SERVICE BULLETIN

No. 186

Piper Aircraft Corporation

SUBJECT: Replacement of Fuel Lines and Fuel Line Fittings

SERVICE BULLETIN 186

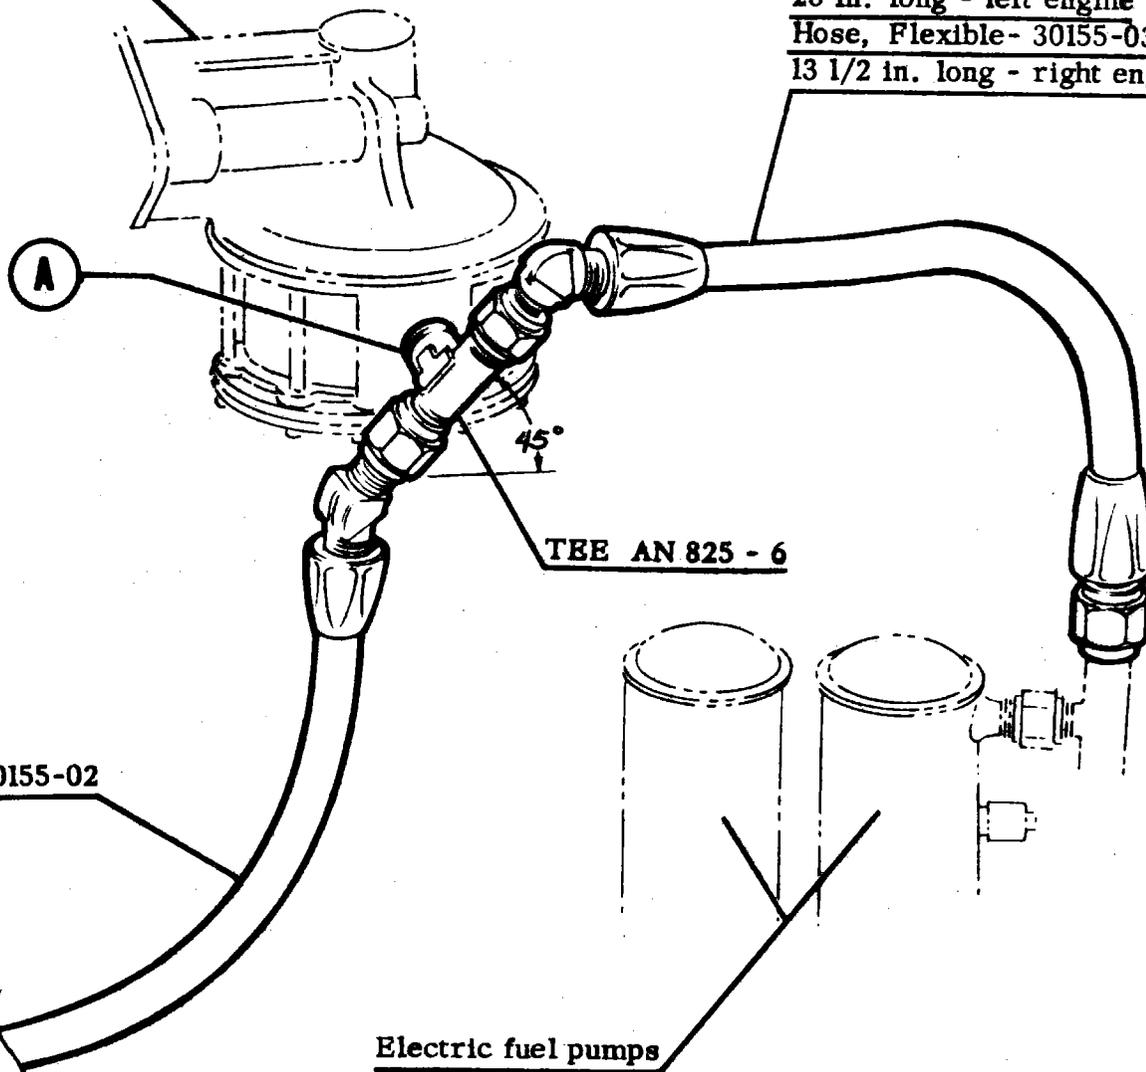
1. The steel line between the engine driven fuel pump and carburetor is to be replaced with a flexible line.
2. The flexible line - outlet from electric fuel pump to engine driven pump is to be replaced with another flexible line.
3. The tee and nipple at each engine driven fuel pump shall be removed and replaced with a new type steel tee. The nipple is eliminated.

NOTE: There shall be a minimum of 3/8" clearance between fuel line, engine driven pump to carburetor, and the engine mount.

The flexible fuel line, electric fuel pump to engine driven pump, left engine, is 20" long; right engine 13 1/2" long. Flexible lines, engine driven pump to carburetor are the same length - 17 1/2" long. Refer to the sketch on reverse side for details of installation.

Hose, Flexible- 30155-04
20 in. long - left engine

Hose, Flexible- 30155-03
13 1/2 in. long - right engine

Remove "TEE" fitting and nipple from engine driven pump at point "A" and replace with "TEE" fitting AN 825-6.
